Agenda Item 3
1150 Highland Avenue
New Residence

Staff Report
Excerpt of April Meeting Minutes
Building Scale Summary
Vicinity Map
Air Photos

1150 Highland Avenue

Amberley Woods Courtyard Homes - Revisions to Previously Approved Plans

PROPOSED SIDE (EAST) ELEVATION
BOSTONIAN FRENCH COUNTRY - 1905 AMBERLEY COURT
PROPOSED CHANGES HIGHLIGHTED

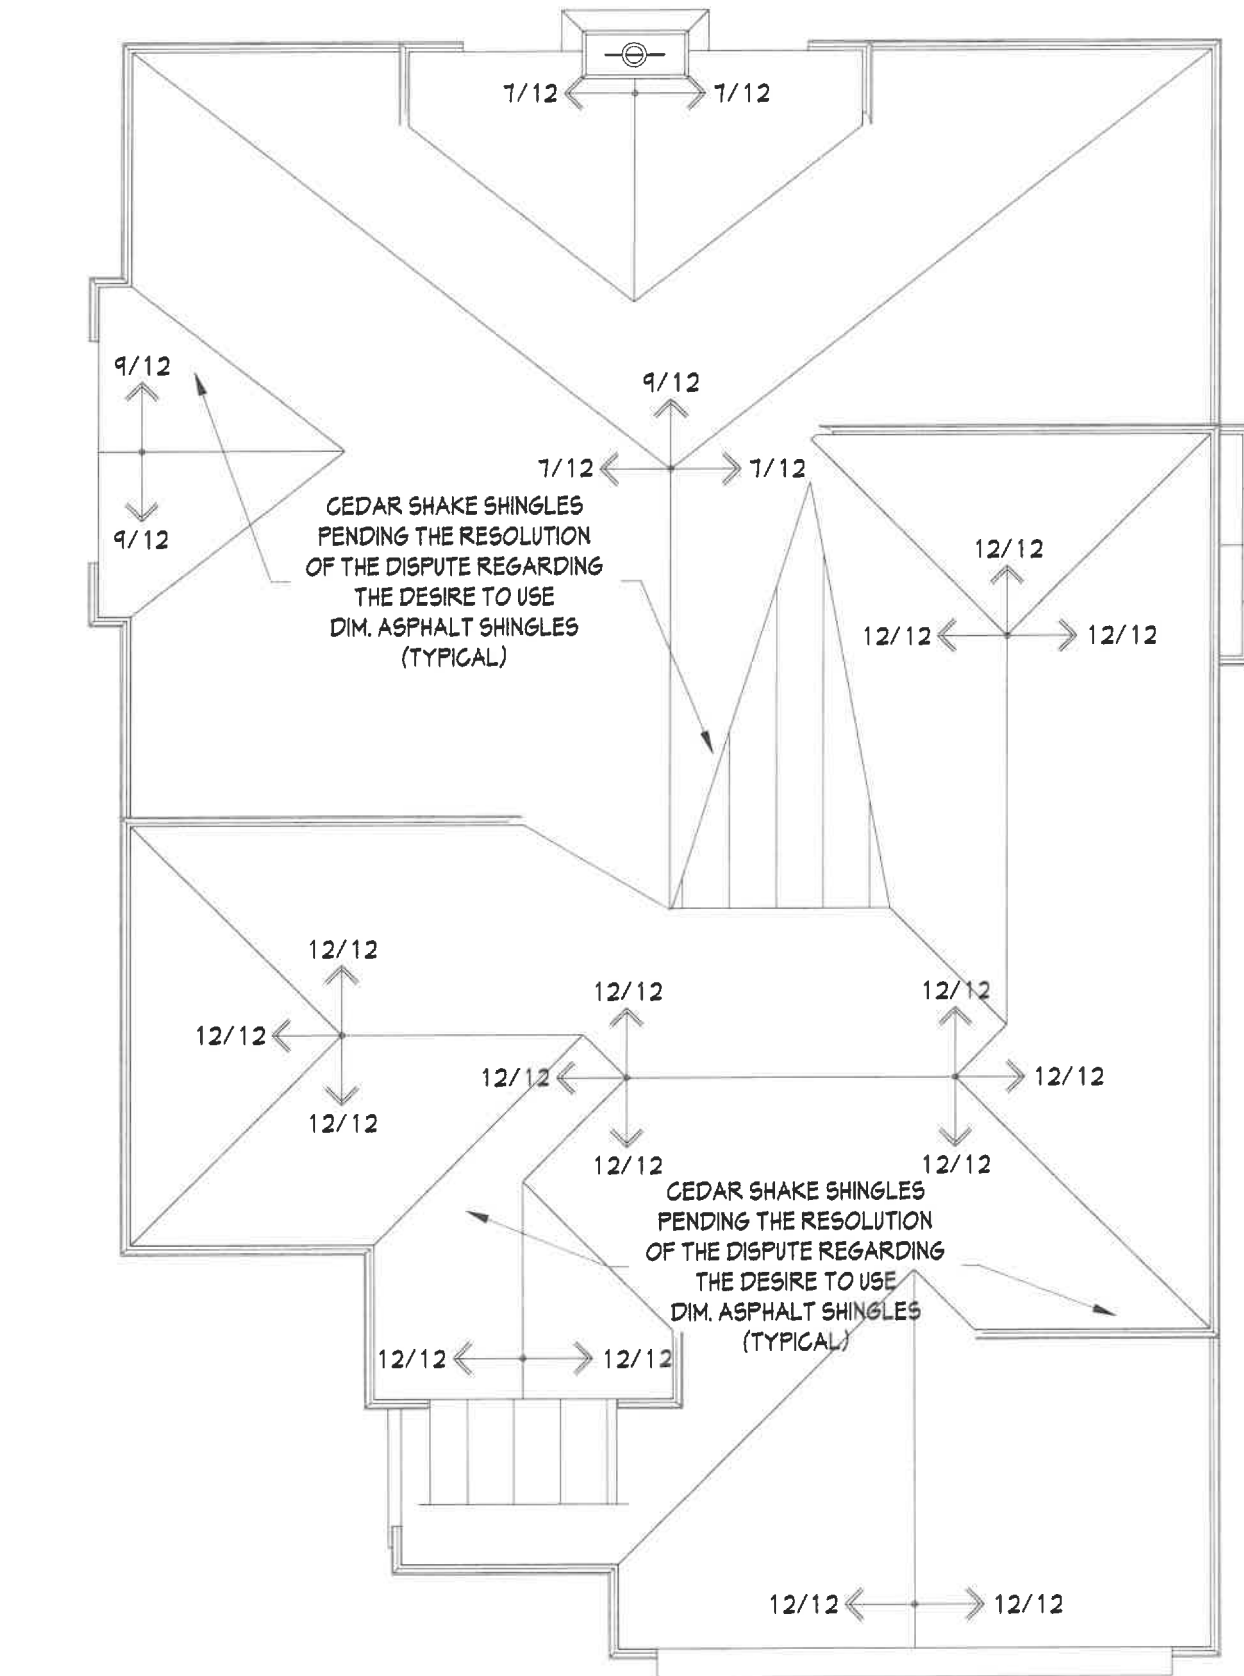
- Narrow double hung windows and shutters were added to north end of the elevation.
 - Staff does **not** recommend approval of this change. The narrow windows present awkward proportions. The window proportions should be refined to more closely match the proportions of the other double hung windows on the home.
- A single casement window was eliminated from the right of the projecting bay.
 - Staff recommends approval of this change due to its minor impact on the overall design of the home.
- Transom windows were added to the left of the projecting bay.
 - Staff recommends approval of this change due to its minor impact on the overall design of the home.
- A single double hung window was eliminated from the south end of the elevation.
 - Staff does **not** recommend approval of this change. The window should be retained in this area to break up the large expanse of solid wall.
